Addendum No. 1

“Phase 1b – Contract D – Elevated Water Storage Tank
Illinois Alluvial Regional Water Company
Jersey County, Illinois

September 29, 2026

The contract documents prepared by MECO-Heneghan Engineers for Phase 1a – Contract D – Elevated Water Storage Tank for the Illinois Alluvial Regional Water Company are hereby amended or clarified as follows:

SITE PLAN

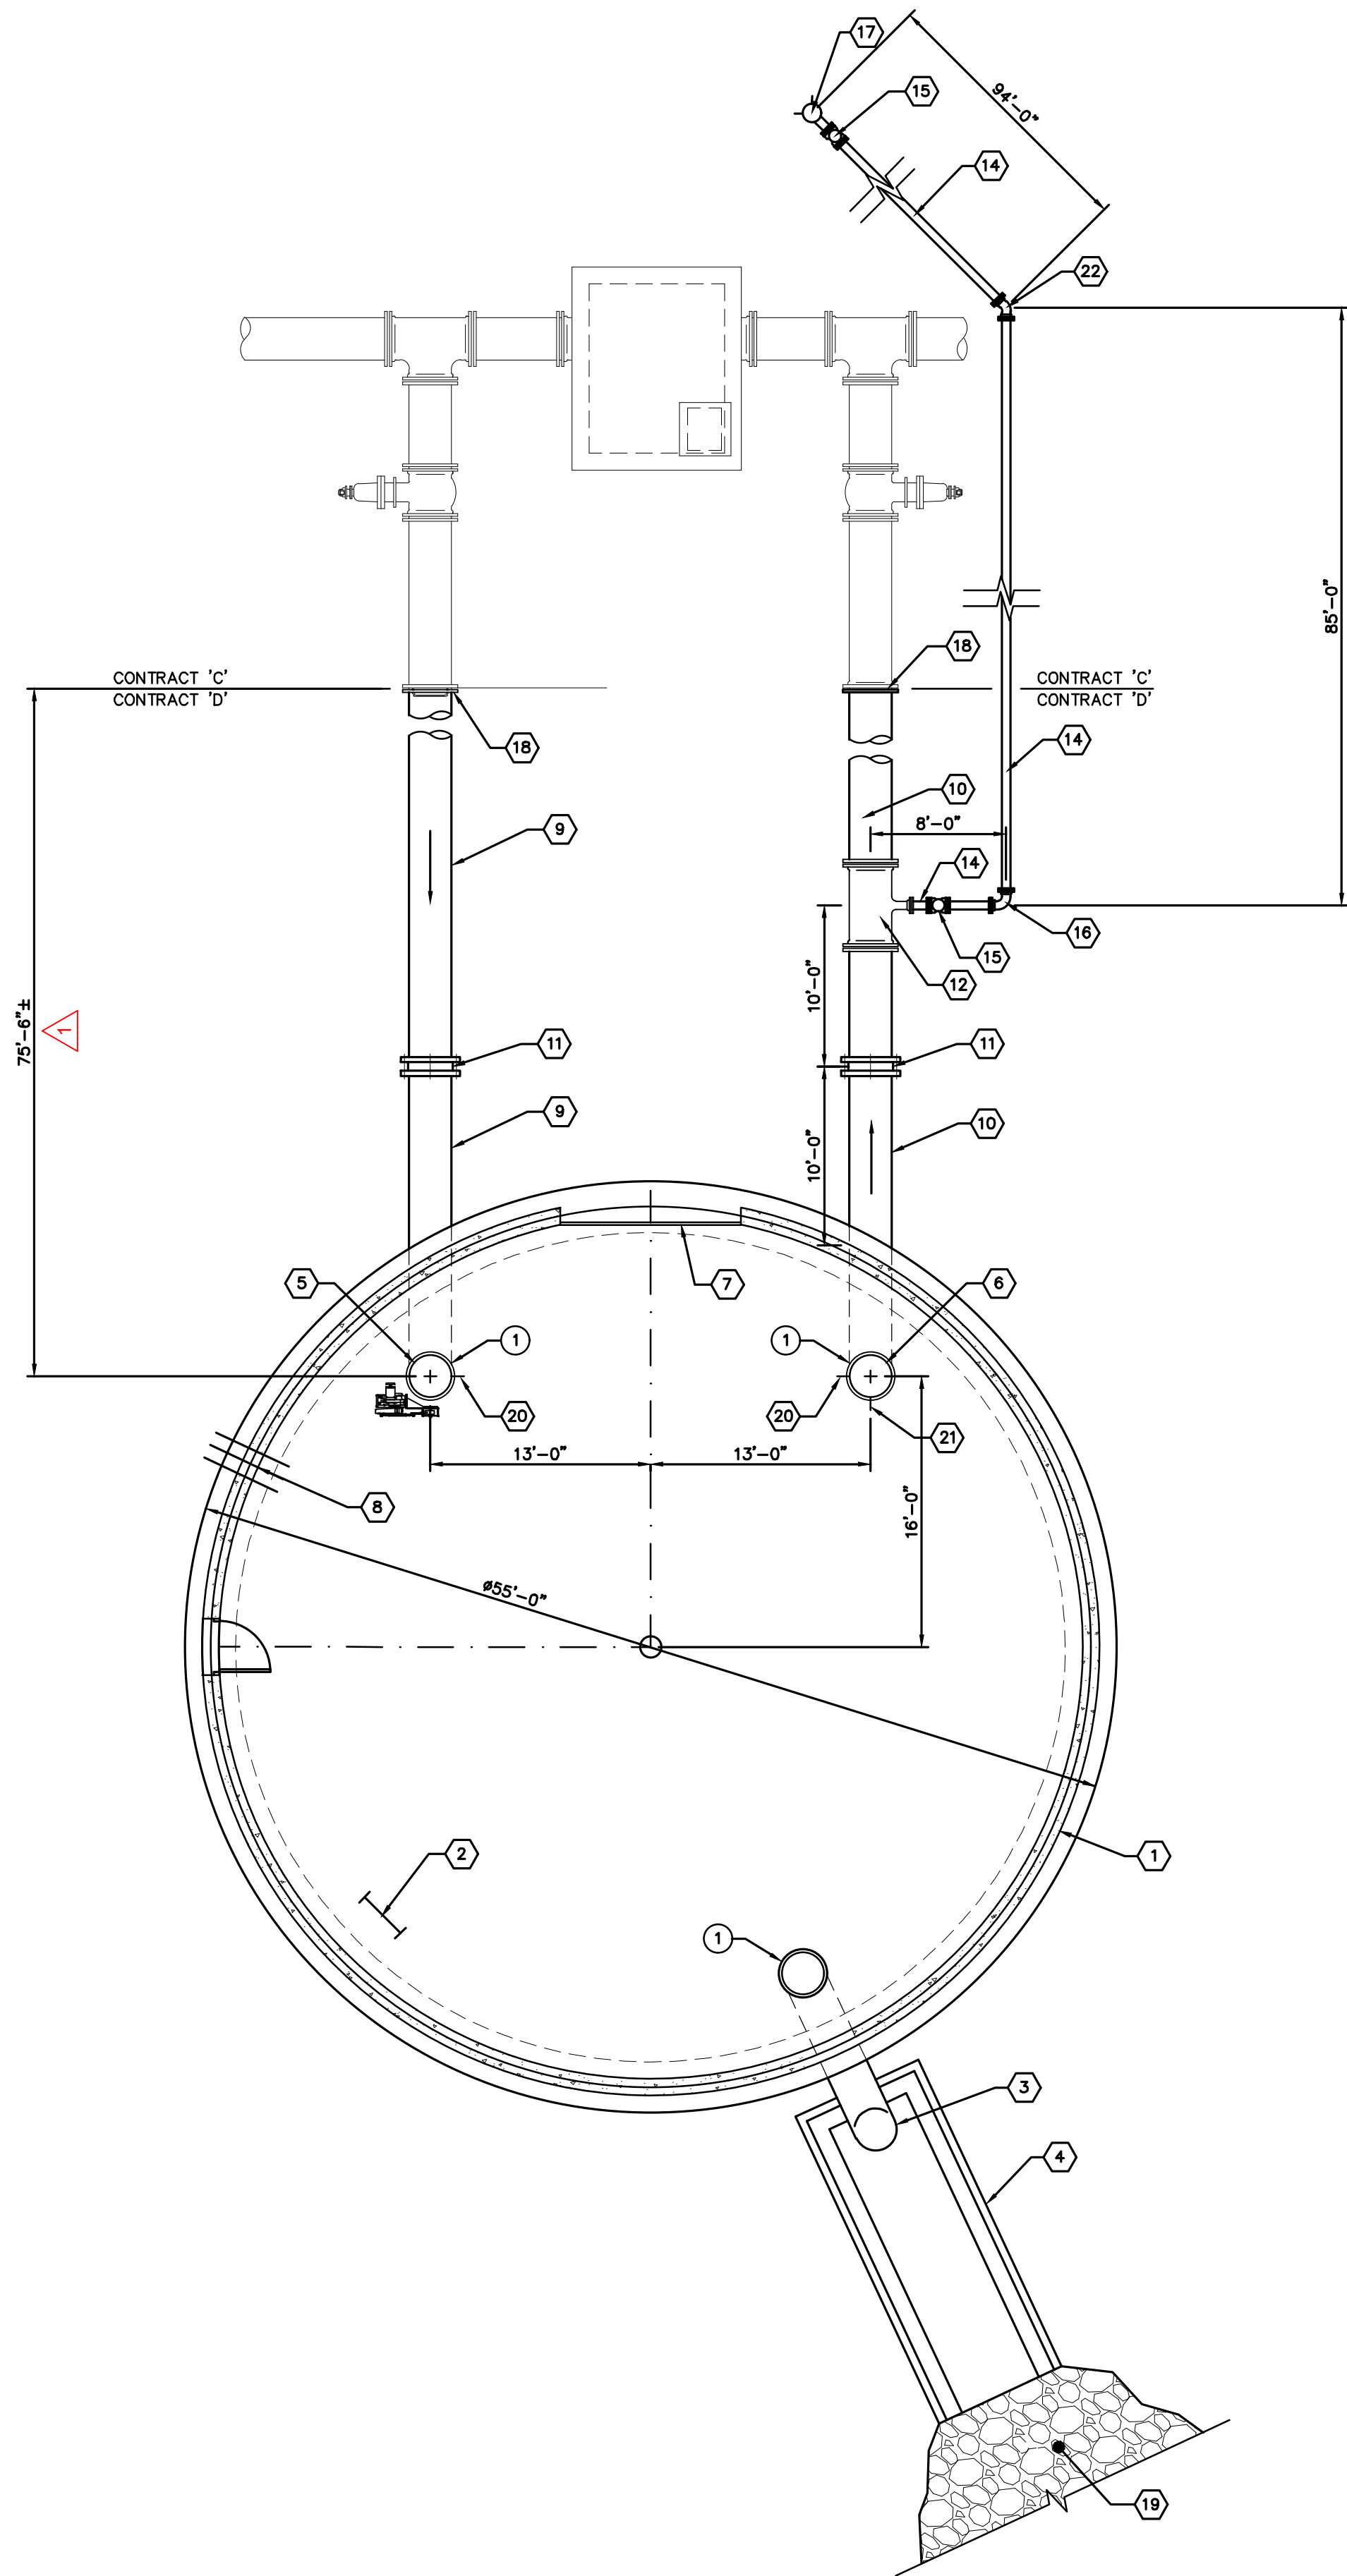
- A. See attached new Plan set. This set shall replace all previous set.
- B. Plan sheet C1 clarifies the distance of piping that Contract D is responsible for.

- D. Can you send a site plan showing the area around the tank and work contiguous to the tank? Trying to determine how much room we will have for staging and sub-assembly. The plans provided with Contract D are tank specific. **See attached.**

- EE. Are we only responsible for the footprint of the tank in terms of site work/grading along with the piping and splash pad indicated on C1 plans? **Grading, splash pad, piping to connect to existing finish main tees/valves and site cleanup and seeding will be responsibility of Contract D contractor.**

1 SECTION
C2 SCALE: 1/16" = 1'-0"

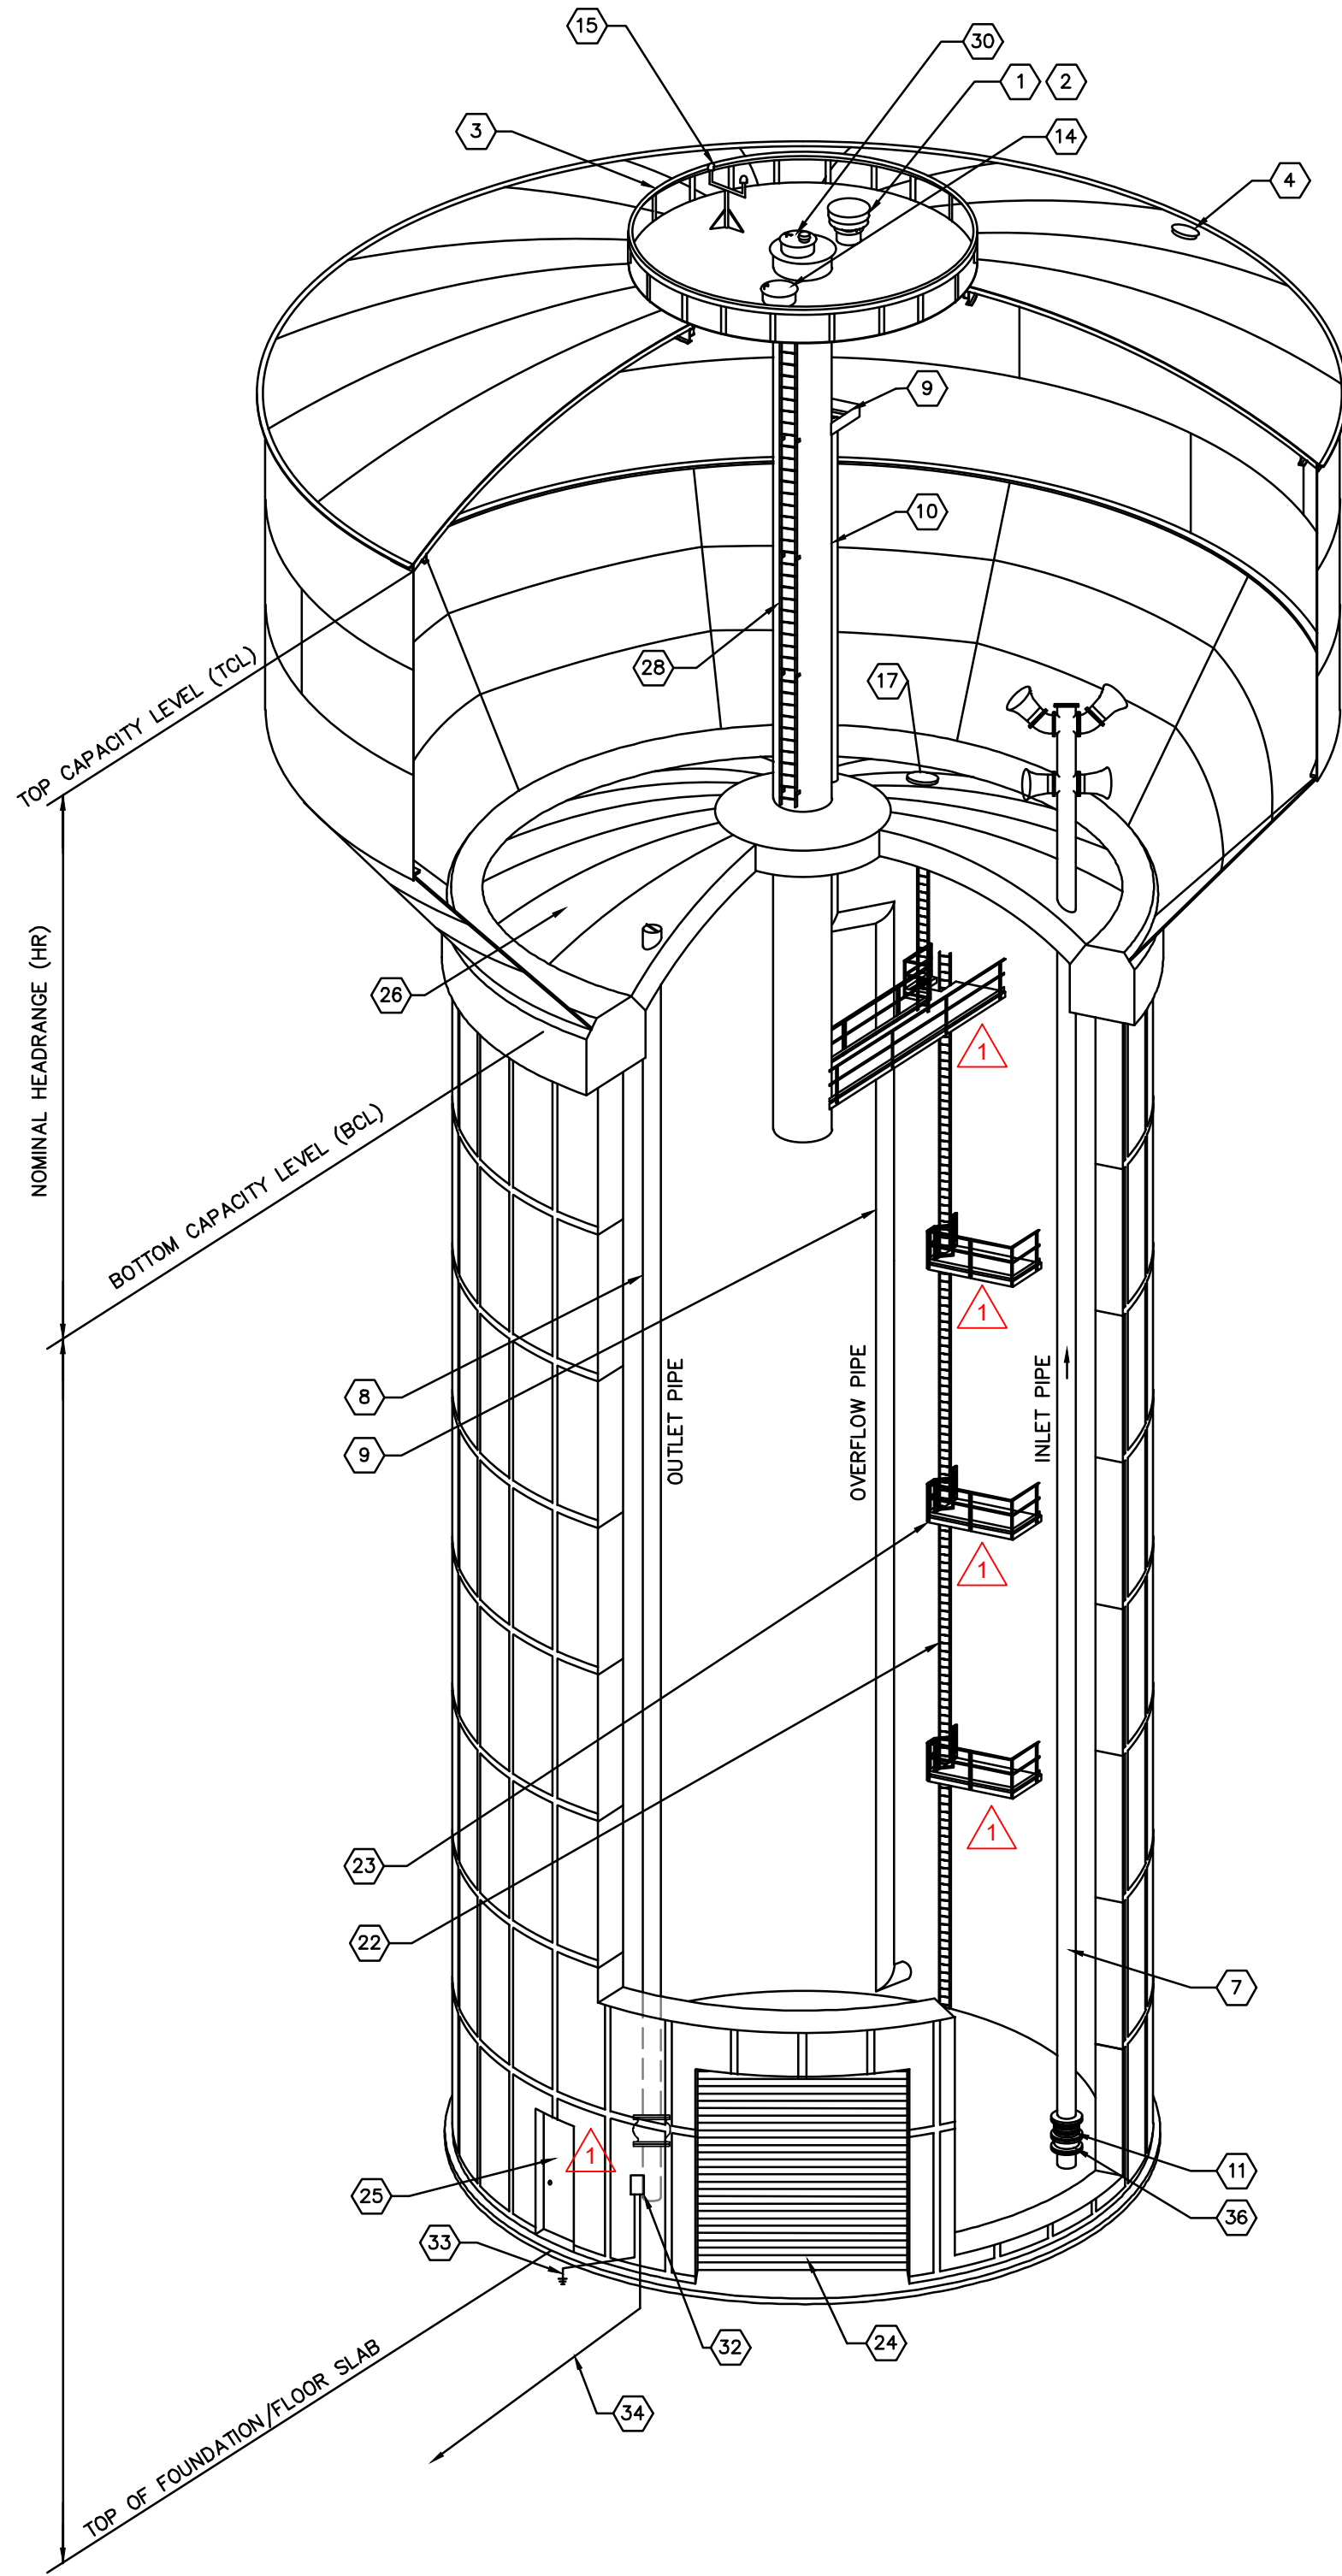
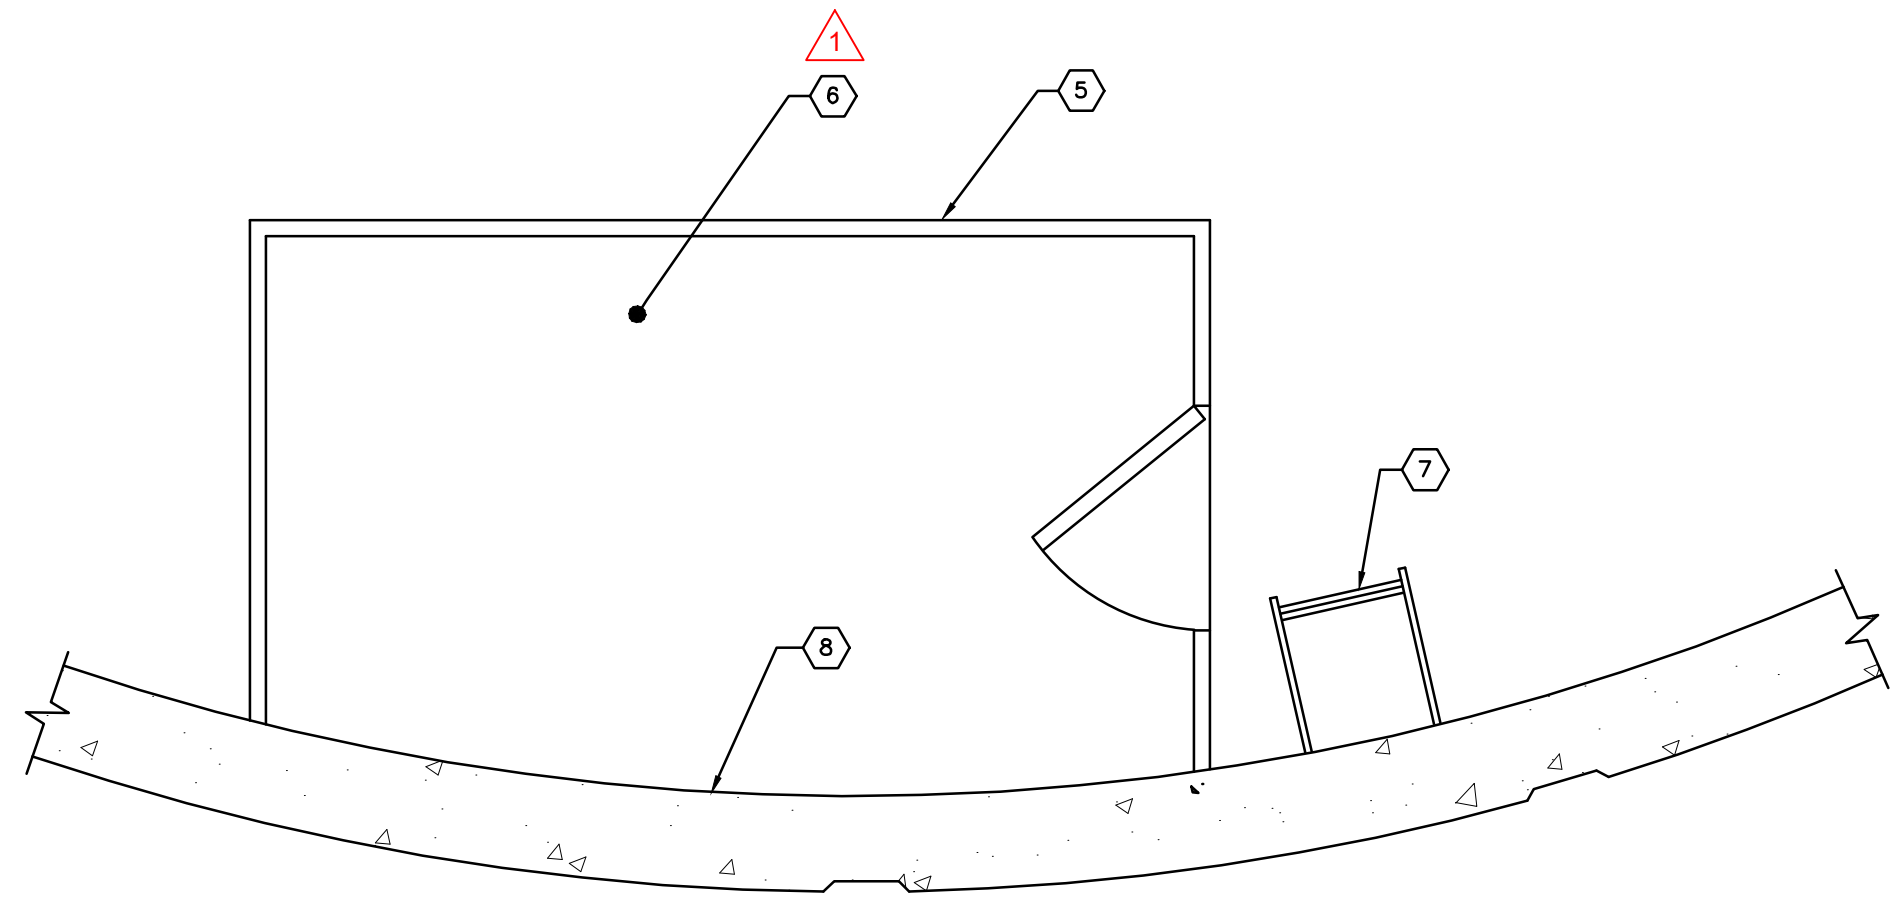
- C. Plan sheet C2 is revised per the attached Sheet C2 and clarifies valve references and riser ladder and landing geometry.
- D. Plan sheet C3 is revised per the attached Sheet C2 and clarifies valve references and detail 6/C3 – This detail governs the tank logo. Final rendering and letter height and width will be confirmed during the shop drawing review phase. The tank shell exterior color shall be Tnemec Tank White, with blue IARWC lettering and black ILLINOIS ALLUVIAL REGIONAL WATER COMPANY lettering below the logo. The water spigot and drinking glass logo shall be black. The reflection under the IARWC logo letters can be omitted.

- E. Plan sheets C2 and C3: tank roof: the bidder has the option to provide shallow cone roof in lieu of the dome style roof shown on the plans.

- K. Specification 33 16 19 - 9 Paragraph 2.08 G.2 requires a 10' x 12' overhead door. Drawing C2 requires a 10' x 14' overhead door. Which is correct? **10' x 14' is correct.**

- L. Specification 33 16 19 - 10 Paragraph 2.08 L.1 requires an inlet/outlet and Drawing C2 shows the inlet and outlet as separate. Is the inlet and outlet one pipe or are they separate? **Inlet and outlet pipes are separate.**

- YY. Drawing Sheet C-2 shows insulation on the overflow pipe. However, this pipe will never be full of static water and therefore insulation is unnecessary. Can you confirm that insulation is not required for the overflow pipe? **Correct.**

- AAA. Drawing Sheet C2 shows a domed roof. This is one specific manufacturer's standard detail. Our standard roof construction is conical in shape, not domed. Either option will minimize snow accumulation and water ponding, and both are acceptable per AWWA D107 standards. Can you confirm that individual manufacturers' standard details will be acceptable? **Dome shape is preferred. Owner will consider a deduct alternative during shop drawing phase for alternate roof style. This has now been revised to include shallow cone roof as an approved roof style.**

- BBB. Drawing Sheet C2 illustrates a ladder system that offsets at each landing. This type of ladder system is not recommended due to the increased safety hazard of unhooking from the safety climb device at each rest platform. Section 331619 Item 2.08.E.1 states that the platforms shall be arranged for a straight run ladder and operable without removing fall protection equipment, which is industry standard and recommended. Can you confirm the vertical ladder inside the concrete pedestal shall be a continuous straight ladder from the slab on grade to the upper platforms? **Offset landings are preferred. See Addendum 1 for revised Section 331619. Revised plan detail clarifies straight ladder configuration and set-off landings.**

- CCC. Drawing Sheet C2 Note #2 states that a galvanized ladder safety device is to be provided. Our standard design utilizes an aluminum rigid rail ladder safety device that meets OSHA standards. Can you confirm both galvanized or aluminum ladder safety devices are acceptable? **Safety climb must be compliant with OSHA and AWWA standard. We will consider aluminum if it conforms to all applicable safety criteria.**

- DDD. Drawing Sheet C2 Detail #24 calls for a 10' x 14' overhead door. Section 331619 Item 2.08.G.2 calls for a 10' x 12' overhead door. Can you confirm that a 10' x 12' overhead door is required? **10' x 14' is required. See Addendum 1 for revised Section 331619.**
